# SERVICE BULLETIN

**Number:** SB0405

**Subject:** New hydro pumps on Premier Series Hydro Walk-Behinds.

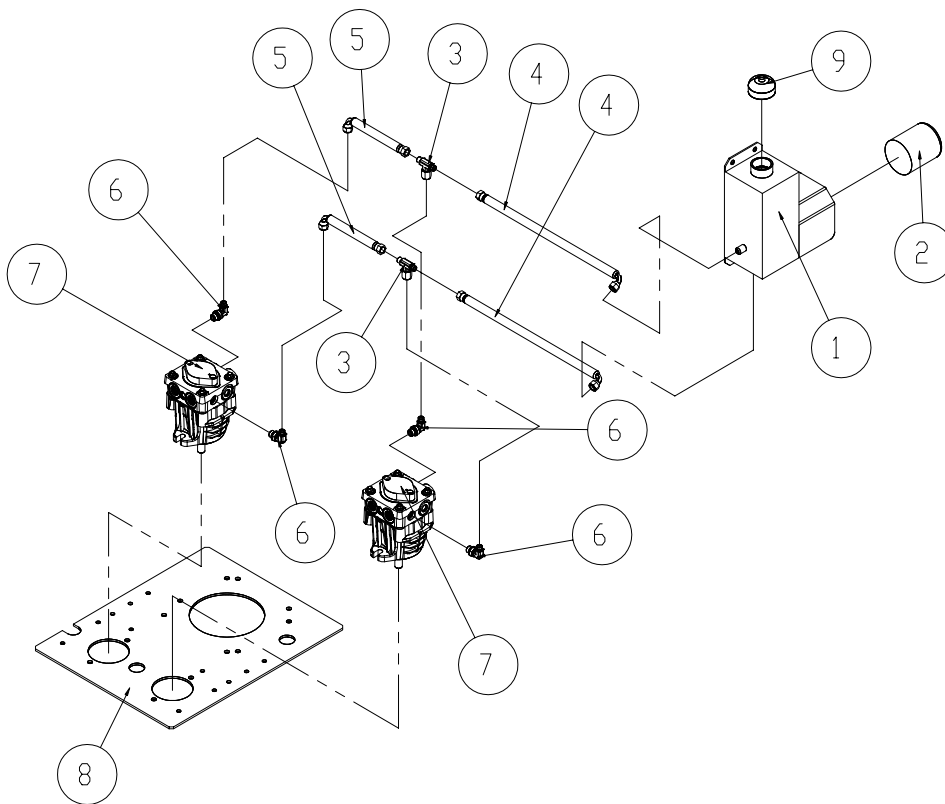
**Details:** A new BDP-10A hydraulic pump and reservoir is now being used on all Encore Premier Series HydroPro Walk-Behind units with serial # 47238 or above. The recommended oil to use is a high quality Mobile 1 - 15w50 synthetic oil. Below is a diagram and associated parts list for the new hydro pumps and corresponding hydraulic lines and reservoir.
